Design/Constructability Staff Review Team

Oak View Group:

KEY ARENA RENOVATION

FIGURE 1
 CURRENT KEY ARENA,
 OUTLINE IN RED

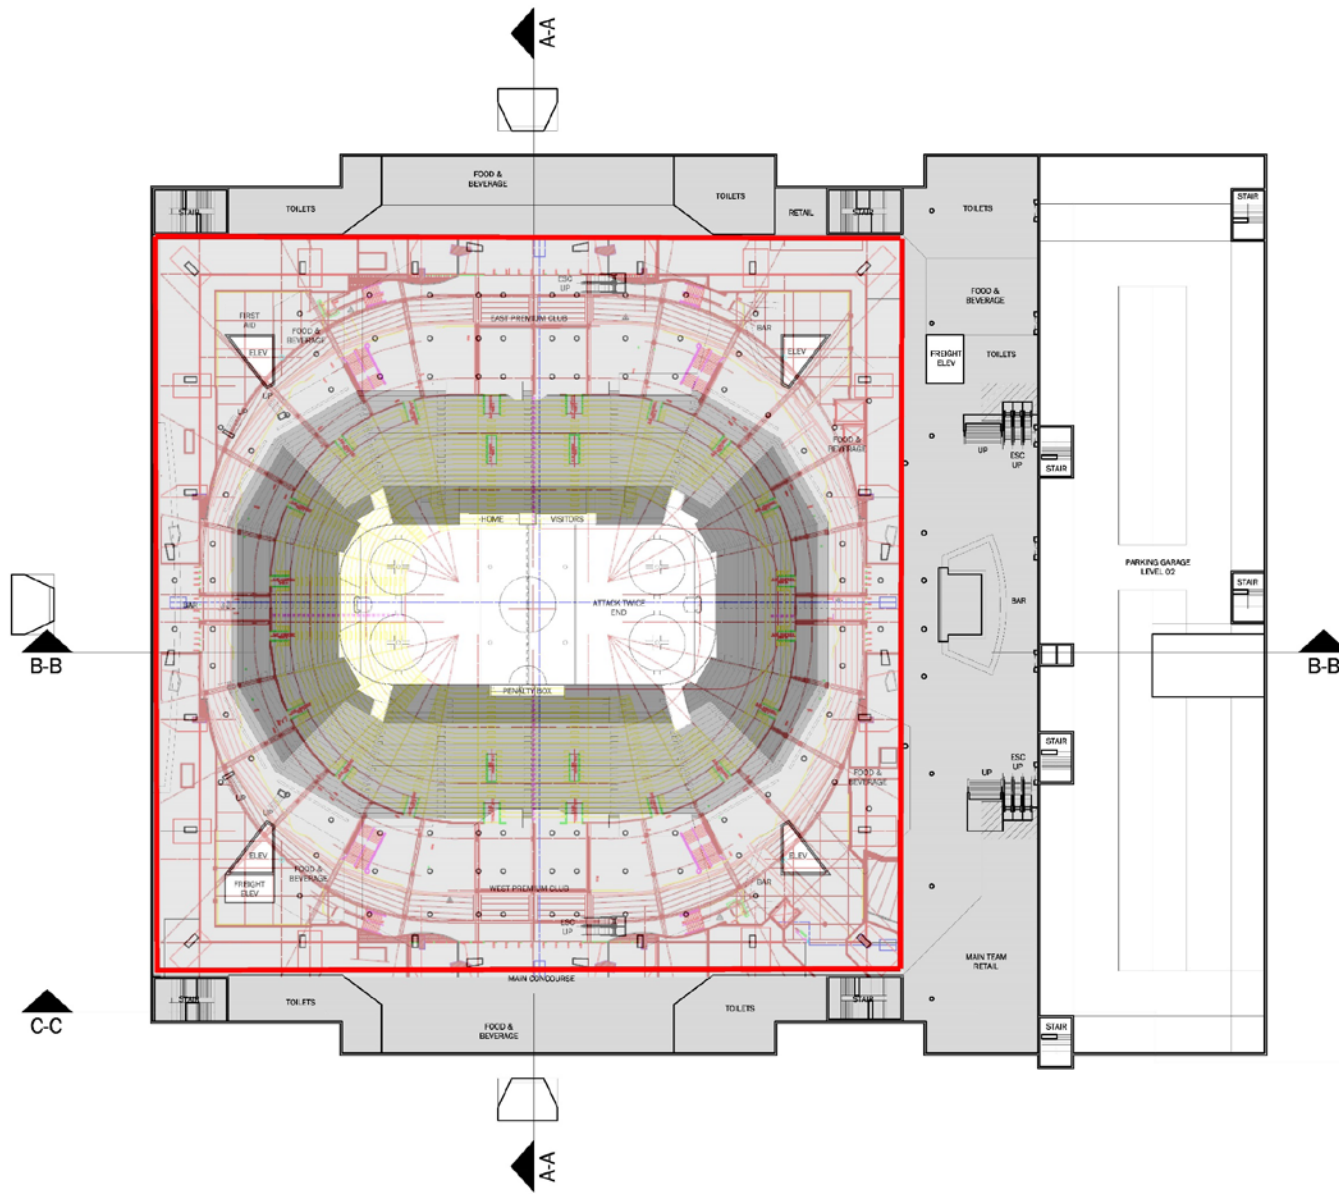
This is a definite strength for this Proposer. By lowering the bowl, and developing a structural plan to transfer load from the four buttresses, they have created essentially a new building, with a large event floor and concourses at new levels. Figure #1 shows the current KeyArena floorplan in red overlaid on OVG’s floorplan. You can see the increased area on all 4 sides of the building.

FIGURE 2
 UPPER CONCOURSE
 GRADE LEVEL
 ENTRIES

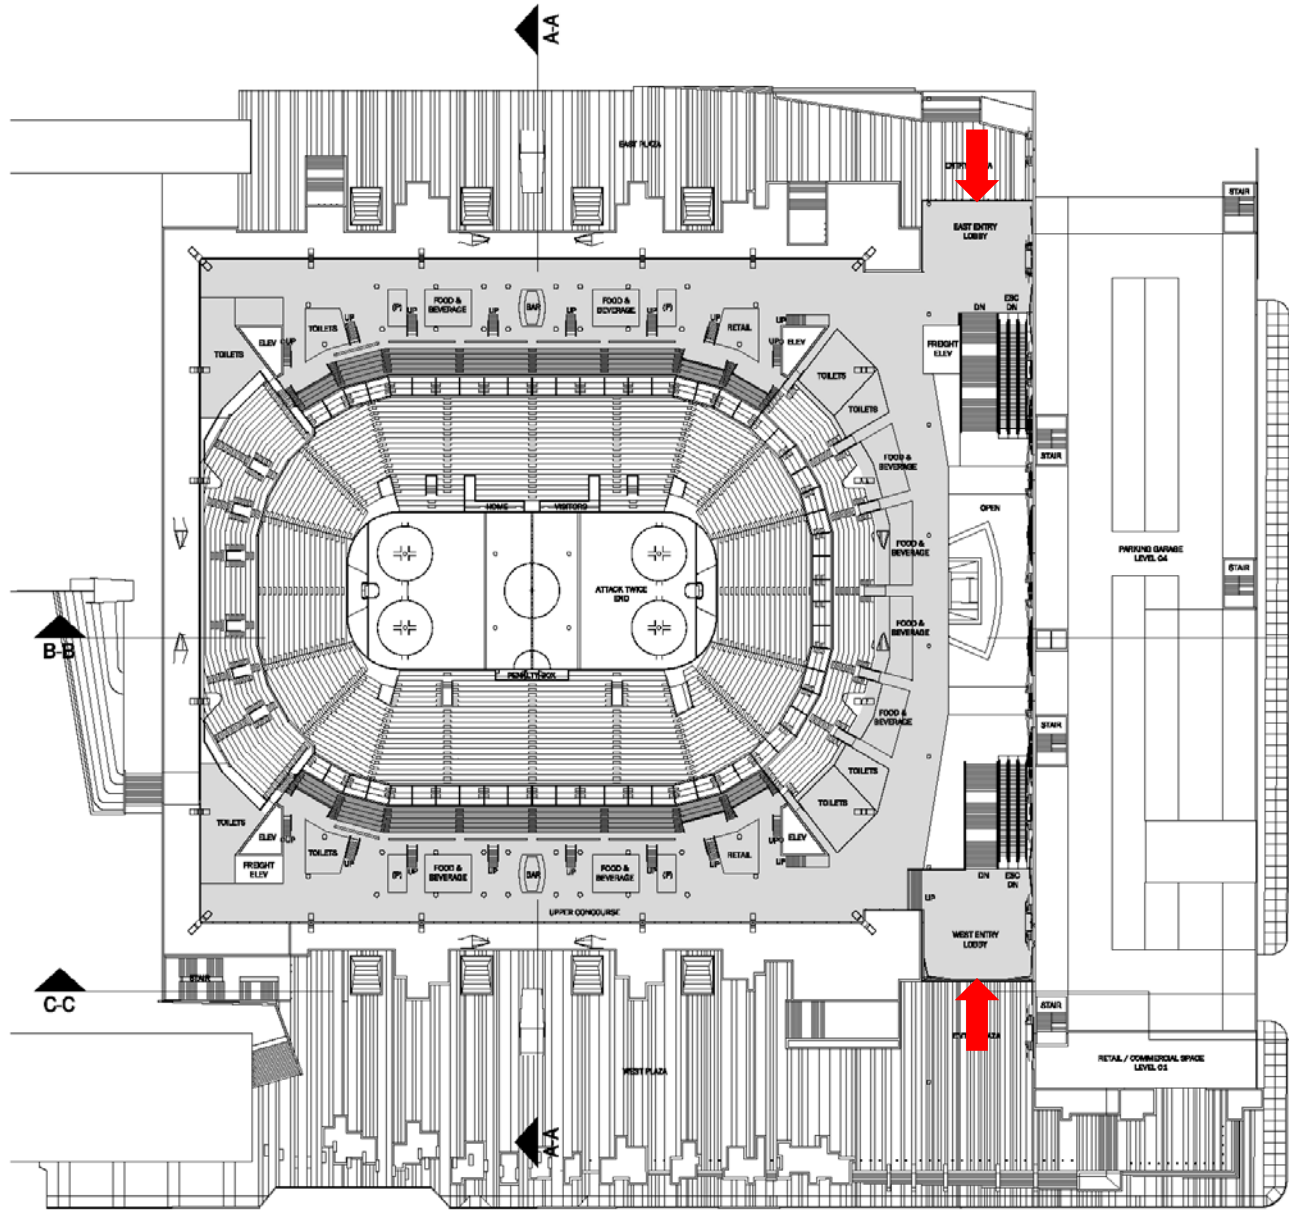
With a large entry at the south end, from the upper level, all patrons drop down into the various building levels (Figure 2).

FIGURE 3
 RED LINE INDICATES
 KEY ARENA SOUTH
 EDGE

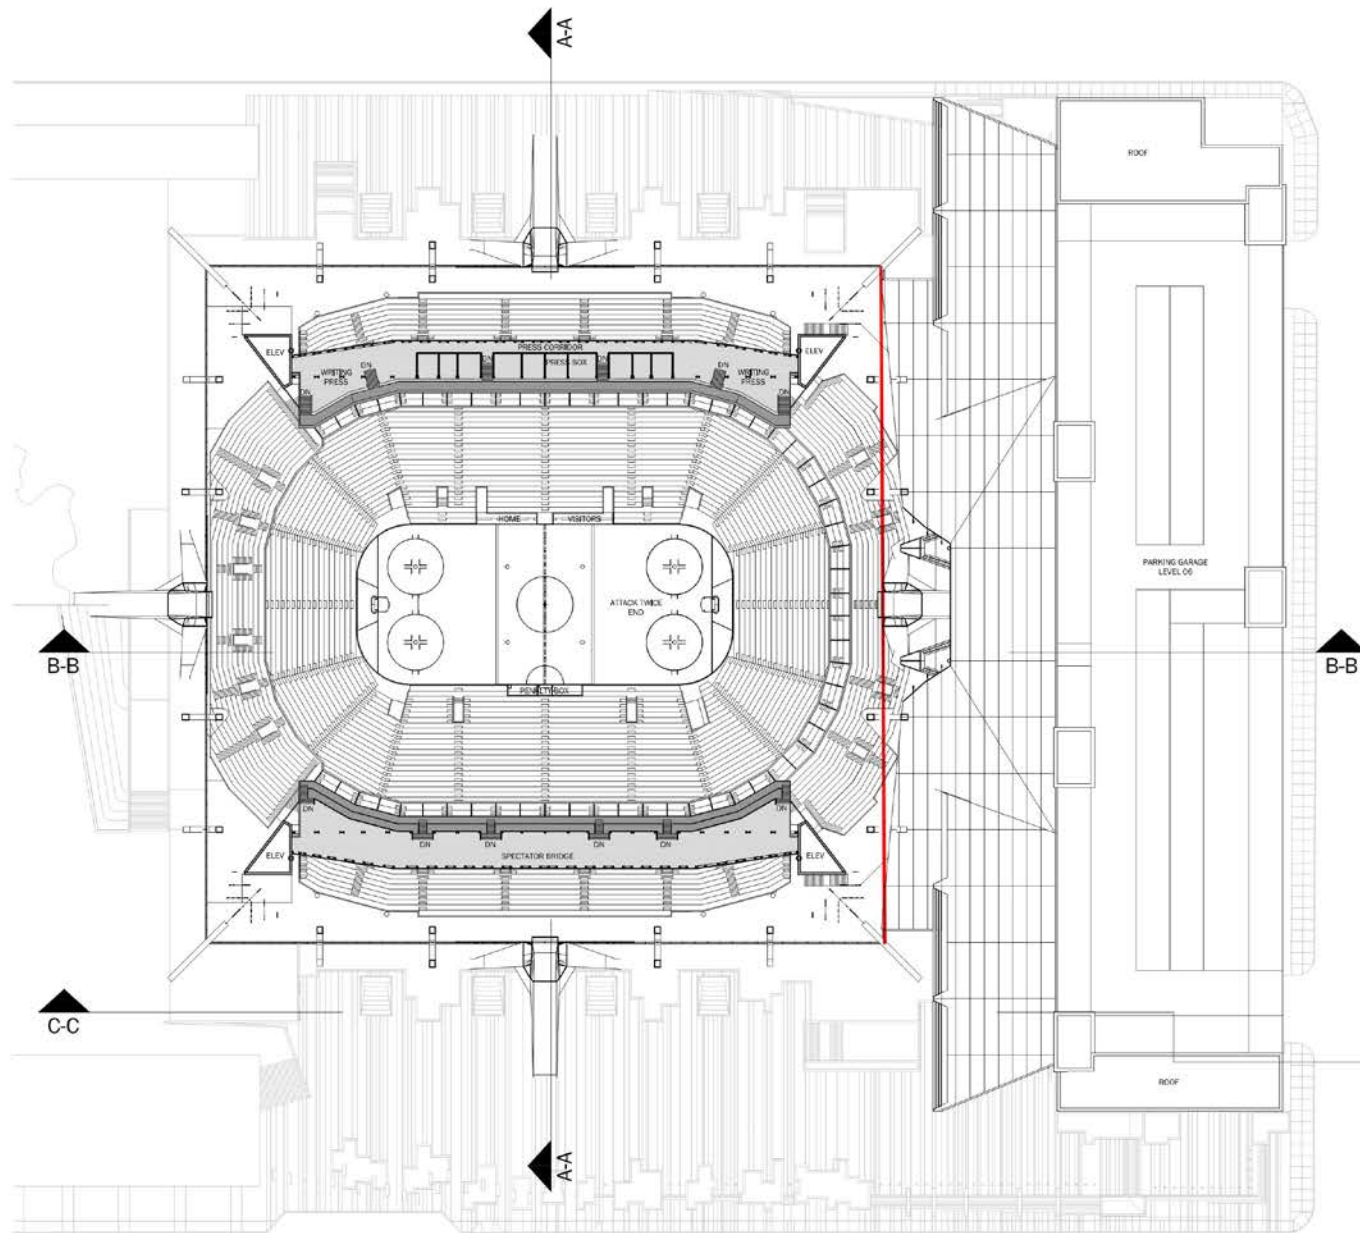
They have provided a new seating bowl and are using 34” riser treads and 20” seating in the lower bowl and 33” treads and 20” seats in the upper bowl. There are multiple upper bowl levels, with the north upper bowl beginning at the suite level, a south seating “party deck” and stacked seating above the upper bowl on the east and west sides. This means that all of their seating fits within the current KeyArena roofline. (Figures 3 and 4)

FIGURE 5

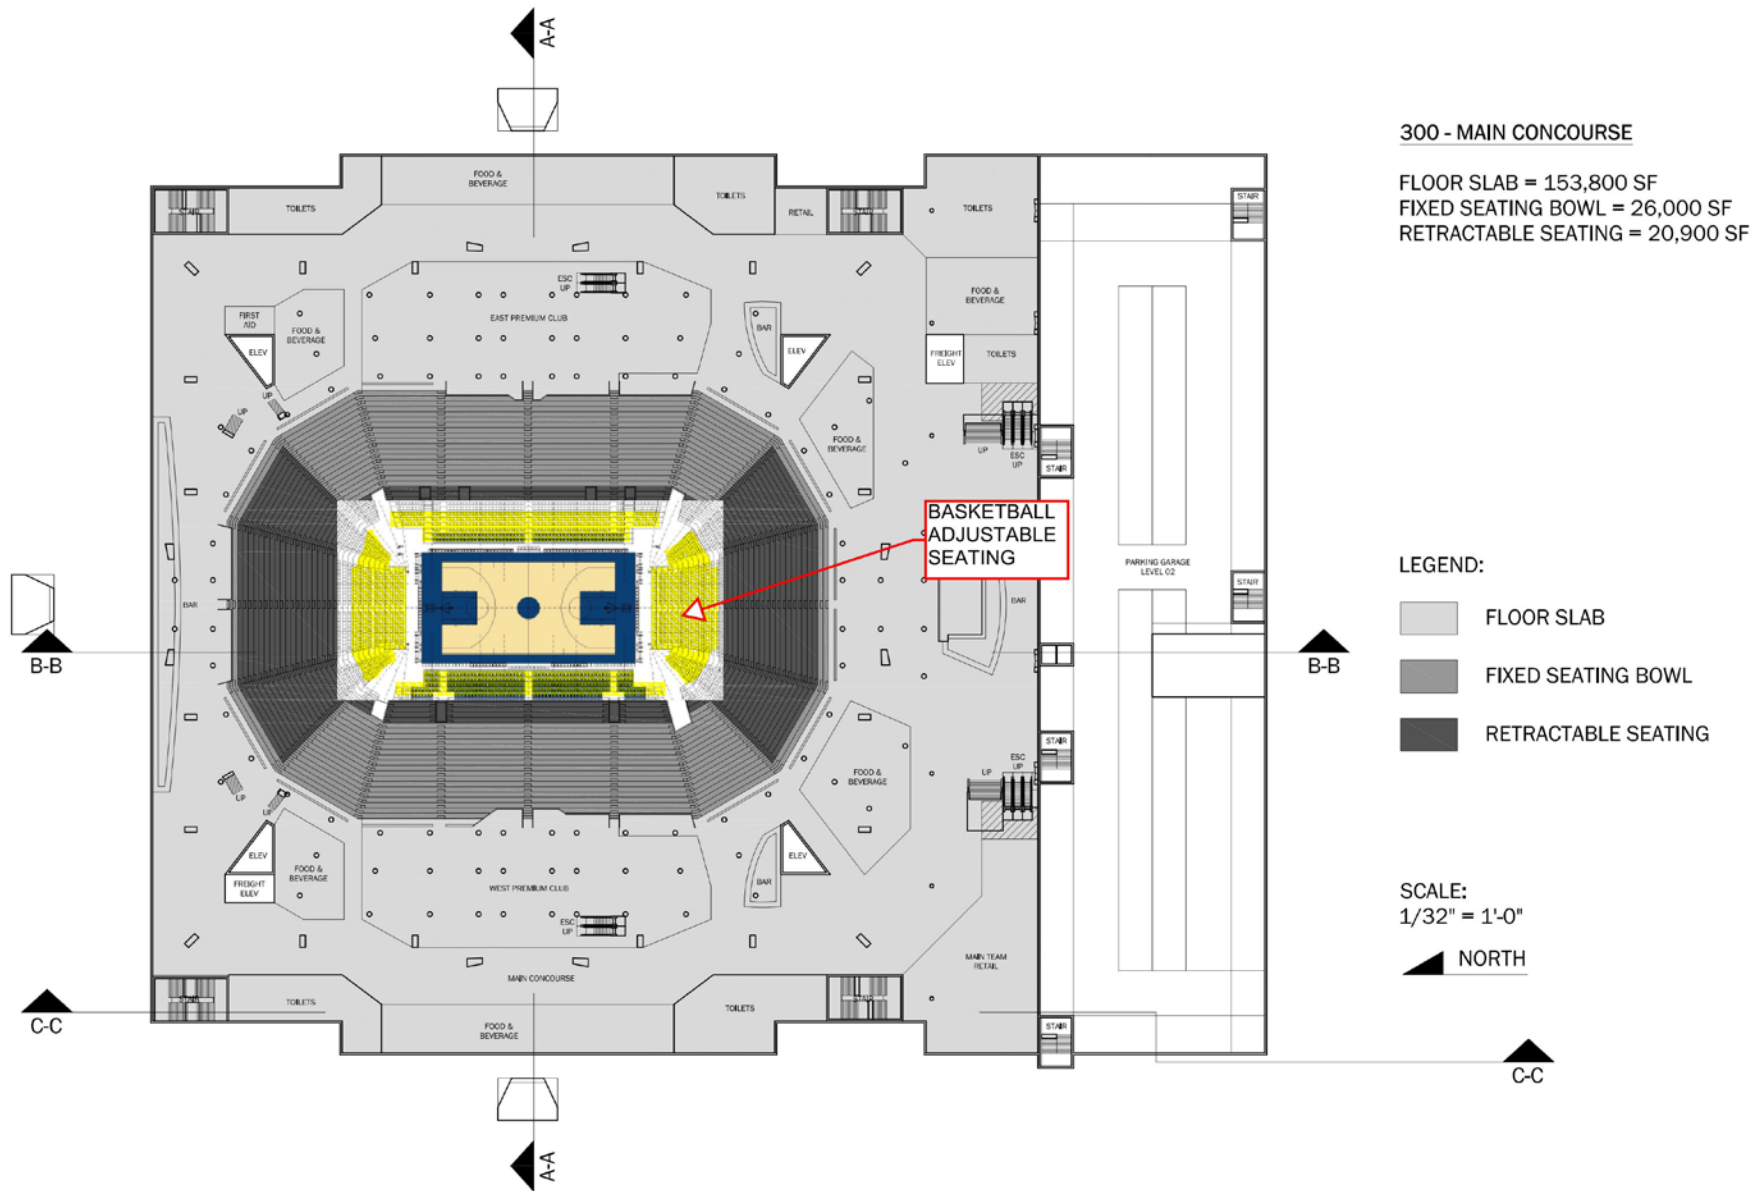
They solve the ice sheet/basketball floor geometry gap - almost 100’ difference between length of ice sheet and length of basketball floor, meaning almost 50’ of space at end of basketball setup until dasher - with adjustable raked seating built into the lower bowl. This creates much better end-zone seating for basketball. (Figure 5)

FIGURE 6
VOLUME OF ADDITIONAL EXCAVATION

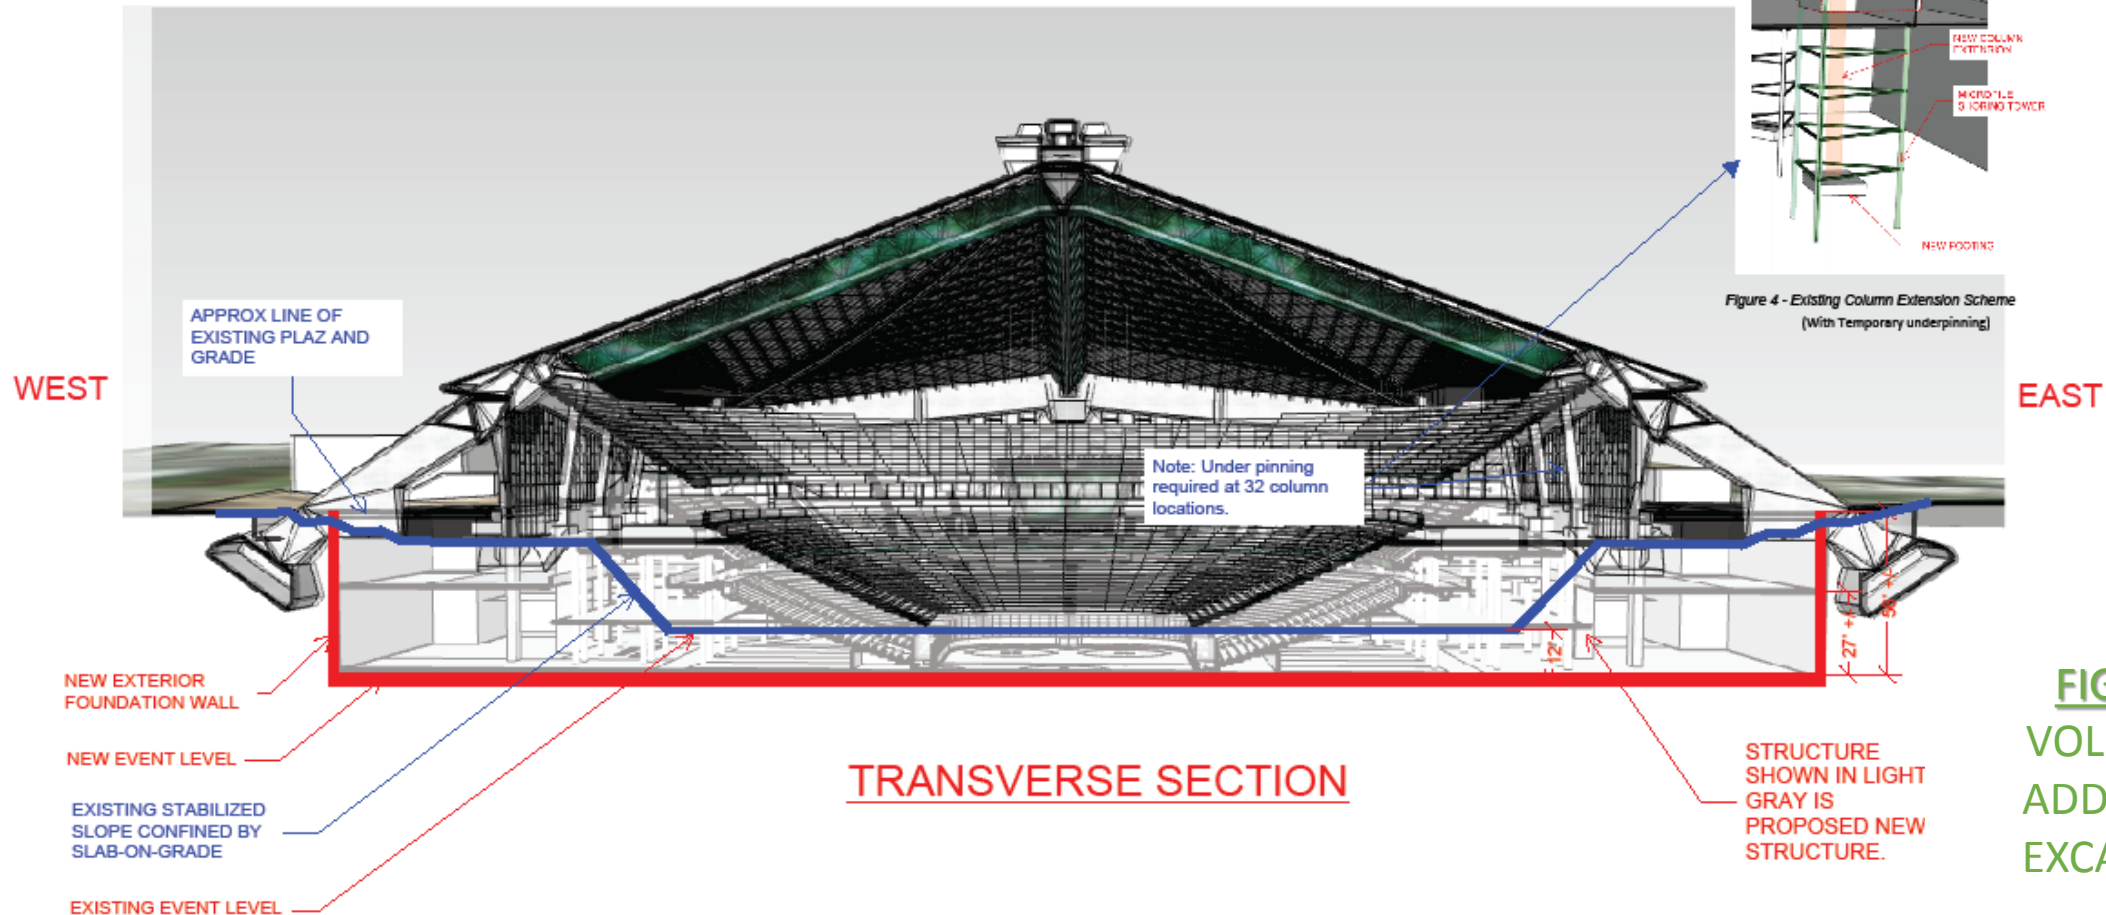
Given that the early milestones in their entitlement process/schedule are unrealistic, the 21-month construction duration (24-month including demolition are comparable with SP's 26-month), which has the most complexity and risk with the deeper excavation (Figure 6), also seems very tight and possibly unrealistic. Please note the construction process is not detailed in their schedule.

OVG proposes to close one block of Thomas St during construction. Due to the amount of excavation and hauling needed for this proposal (Figure 6), there will be potential traffic impacts on neighboring streets. It requires a detail analysis and mitigation measures to reduce impacts during construction.
